Response to Environmental Statement in relation to Berden Hall Solar Farm (Pelham Solar)

PINS Reference: S62A/22/0006

Section 62A Planning Application: S62A/22/0006 Berden Hall Farm, Ginns Road, Berden:

Further Representation on Transport and Highways Matters on behalf of **Local Residents**

Photo 1: Section of narrow carriageway looking north (2km north of Manuden) showing clear signs of vehicles over-running embankments

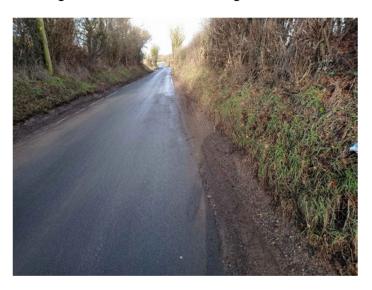
- 2.5 The proposed route to the site from the A120 is of varying standard with some sections around 4.0m in width, insufficient to allow an HGV to pass a car and sufficient only to allow two cars to pass at very low speeds. An HGV passing a cyclist on one of these narrow sections of carriageway would be hazardous. Particularly narrow sections are present at Hazel End, and approximately 2km north of Manuden although there are long

sections of highway with no central white lines suggesting widths insufficient to allow two light vehicles to pass except at low speeds. There is frequent evidence of cars over-running verges and embankments along narrow sections of carriageway:
